From: Roberta Hoy [mailto:roberta.hoy@aata.com]
Sent: Thursday, June 24, 2010 1:45 PM
To: Oxenberg, Tanya
Cc: Charles.Kelsey@ur-energyusa.com; Ping Wang
Subject: Lost Creek Project - Figure 5.1-1

Lost Creek Project
Docket No. 40-9068
TAC No. LU0142

Figure 5.1-1 Lost Creek ISR, LLC Organization Chart

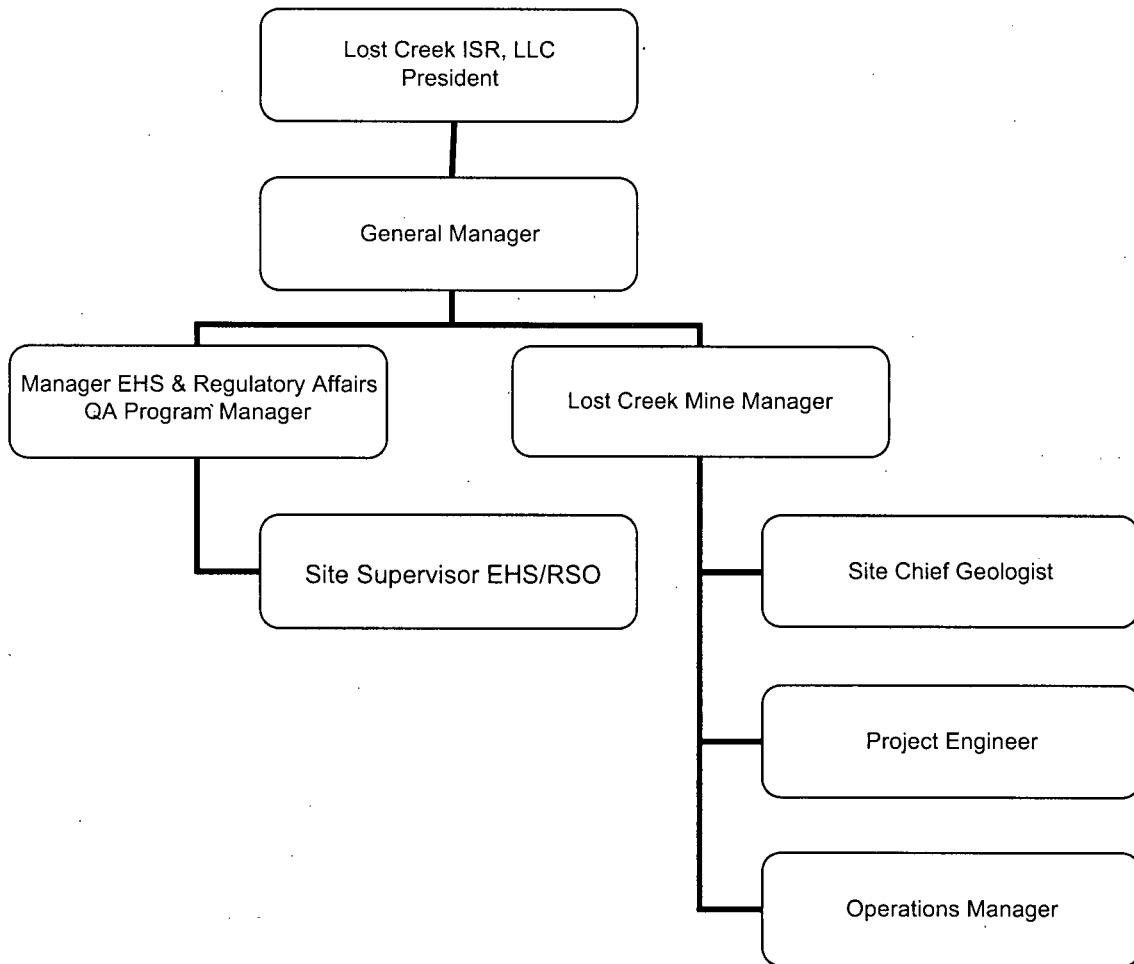
As requested by Dr.Kelsey with Lost Creek ISR, LLC, attached is the revised Figure 5.1-1 (Lost Creek Project Management Organization Chart) with the requested change. Specifically, the phrase "QA Program Manager" has been added under "Manager EHS & Regulatory Affairs", which is consistent with Section 5.1.4 of the Technical Report.
